ARCHENGIN:	Designer
DRAWN:	Author
CHECKED:	Checker
DATE	06.18.21
REVISION	DATE
JOB NO.	180649
SHEET NO.	DP.03

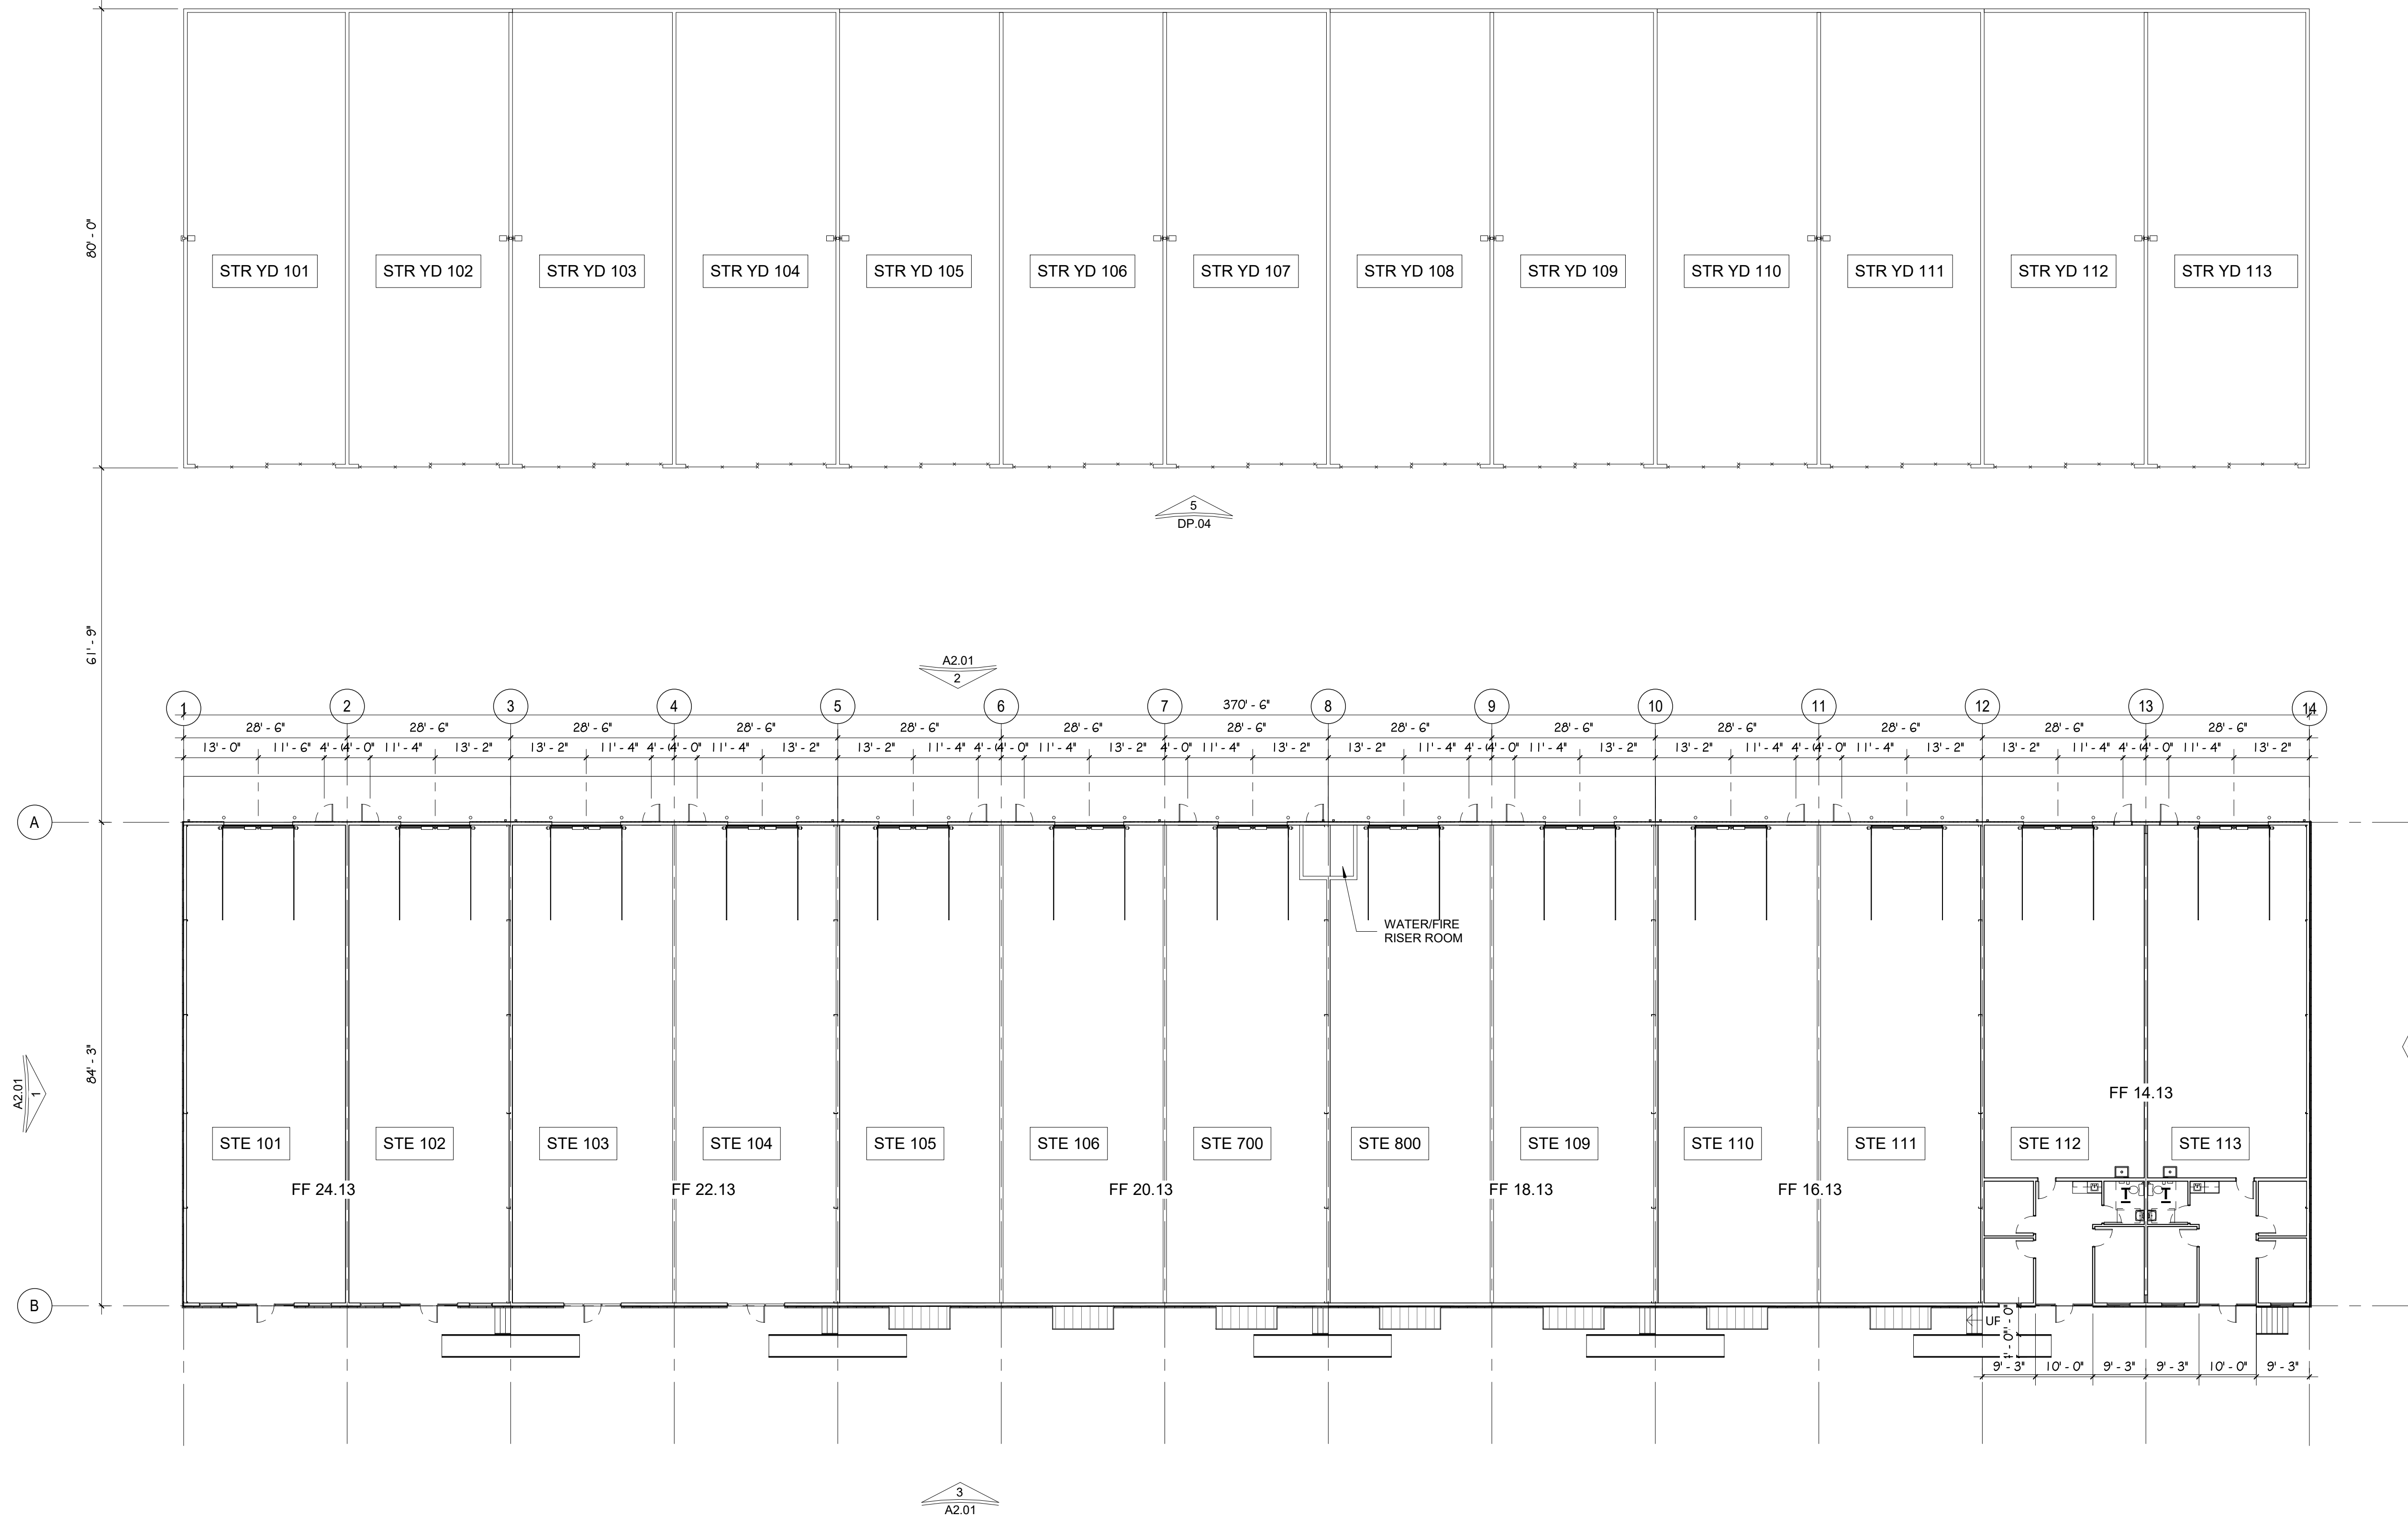
Please revise to show breakout of floor space dedicated to office uses/vs warehouse uses per comments on site development plan
